6 May 2015

Michael Meehan
Planning and Environment Manager
West Coast Regional Council

This letter report addresses the request for advice about proposed floodway cut options between the Orowaiti River/Lagoon and the Tasman Sea at North Beach to alleviate flooding risk to Westport residents (Figure 1 to 3). The scope of this assessment is intended to be relatively high level, and specifically to consider the impact from coastal processes to inform option development and decision making.

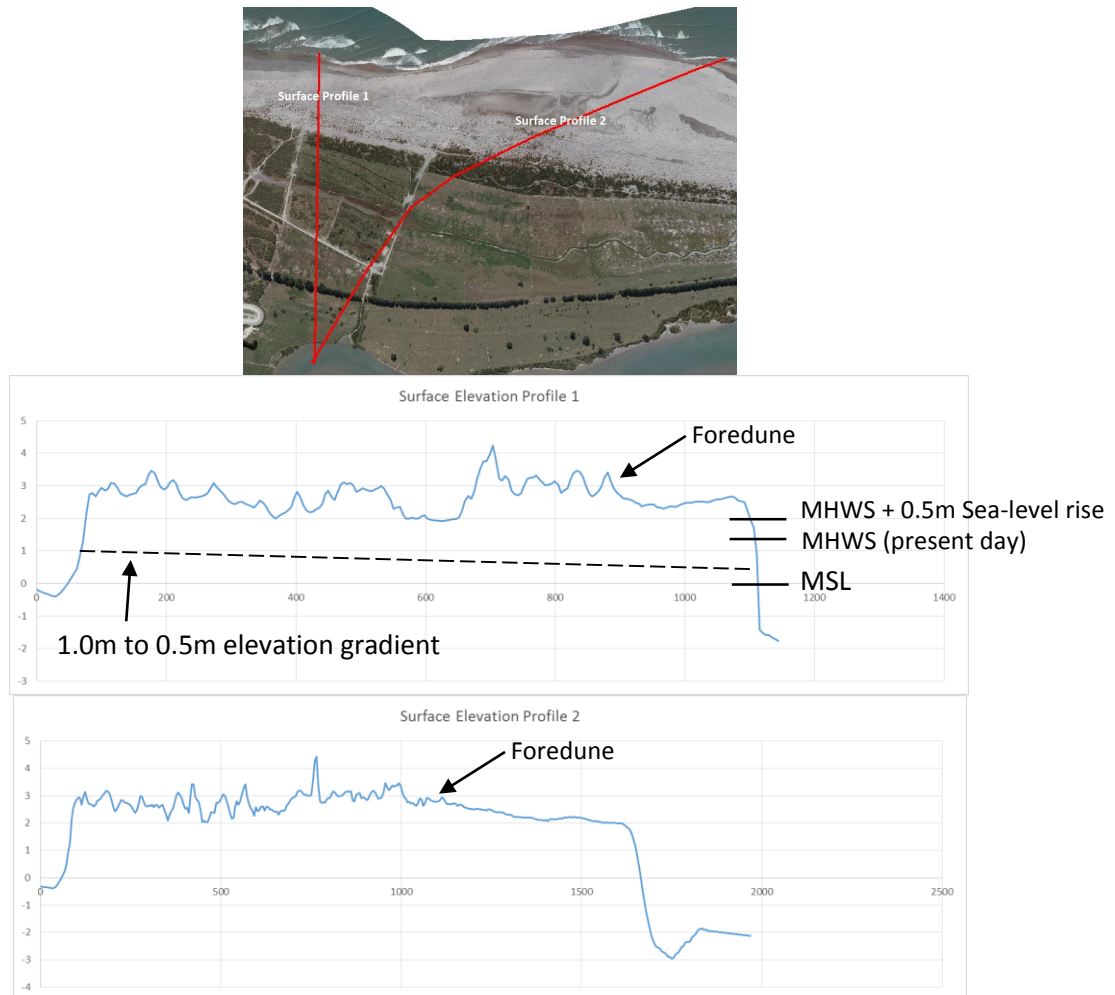
The design depth or invert level of any floodway should take into account the level of local tides, storm-tides and sea-level rise in addition to the necessary efficient discharge of floodwaters. The level of the surrounding land also impacts the safe discharge depth of the floodway. Present ground surface elevations for the proposed floodway alignments (curved and straight) are shown in Figure 6.

The first stage of the modelling viewed for this report (LRS options report presentation) and the commission for this advice were based on modelling of the temporary floodway cut excavated to an elevation of -0.5m AVD-37, and assuming the offshore boundary at the sea does not impinge on the floodway's ability to convey water. This initial model run suggested up to 50% of the total volume (approx. 1,200 – 1,500 m³/s) through the Orowaiti River may discharge through the floodway at peak rates of about 600 m³/s (LRS email to M. Allis 30-3-2015). This depth of excavation would likely result in permanent diversion of the lagoon through the floodway as it represents a more hydraulically efficient discharge pathway than the current path. A stop-bank type barrier at either end (river and beach) would be needed to prevent the river permanently changing course, and after the flood peak subsides the bunds would require rebuilding – which would be difficult if the river has permanently changed the bathymetry to align with the floodway.

approach appears to provide a reduced flood risk to Westport (and stays true to the river-focused rationale), however it does not incorporate risks associated with coastal-driven flooding hazards and a permanent and wide channel up to 0.5m below MSL would bring substantial risk to Westport from storm-tide inundation scenarios of sea-level rise.

3. Pre-excavate floodway cuts to a level not below MHWS and be prepared to accept potential localised flooding within the floodway from coastal-driven storm-tides, and recognise that with future sea-level rises the frequency of this flooding will increase.

5. Create substantial floodway bunds at the lagoon and sea ends of the floodway to prevent heightened storm-tide inundation risk to Westport. These should be of similar height to the existing frontal dune system. Consider the time taken to excavate these bunds and the relative level of forewarning provided for a large flood event.
